TO: Mayor and Town Council

FROM: Joseph A. Fivas, Town Manager

DATE: September 9th, 2014

SUBJECT: Old Monroe Road Widening Project Recommendations

Fig. 6.7.5 Four Lane Village Center Boulevard Cross-section

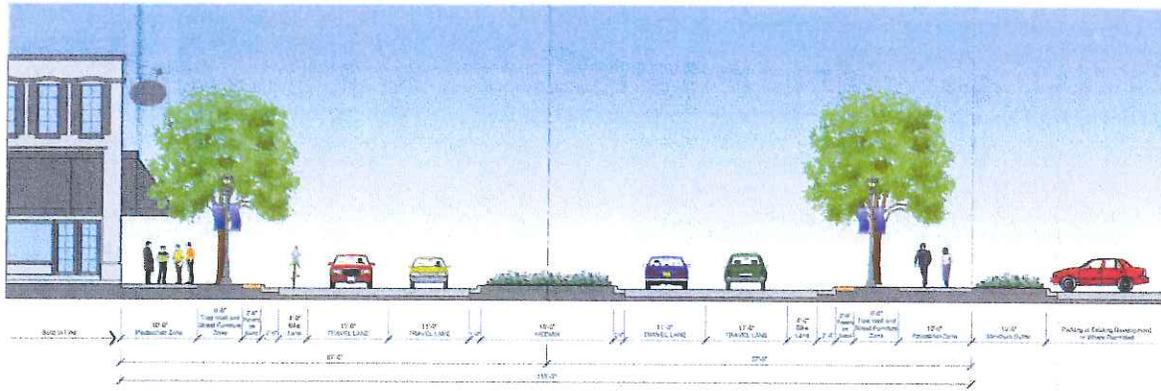
Bryson Road through Wesley Chapel-Stouts Road: The Town requests to use the Town's adopted Four Lane Village Center Boulevard Cross-section. (Attached).

- 1) Remove the 4-foot bike lane throughout cross-section.
- 2) Narrow the center median to 10-feet, or less, from South Fork Road through Indian Trail Road intersection.
- 3) Add vertical landscaping in center median to some agreed upon sections of this road.

- 1) Due to removing the 4-foot bike lane, the Town requests to have project to pay for full cost of 10-foot multi-use path on one side of the road. The Town will work with NCDOT to determine which of road the multi-use path will be located. The Town's hope is to coordinate with Town of Stallings and Town of Matthews.

- 7) The Town would reduce the sidewalks sections at Indian Trail Road and Wesley Chapel Road intersection areas to 6 feet.
- 8) The entire section must have curb and gutter.
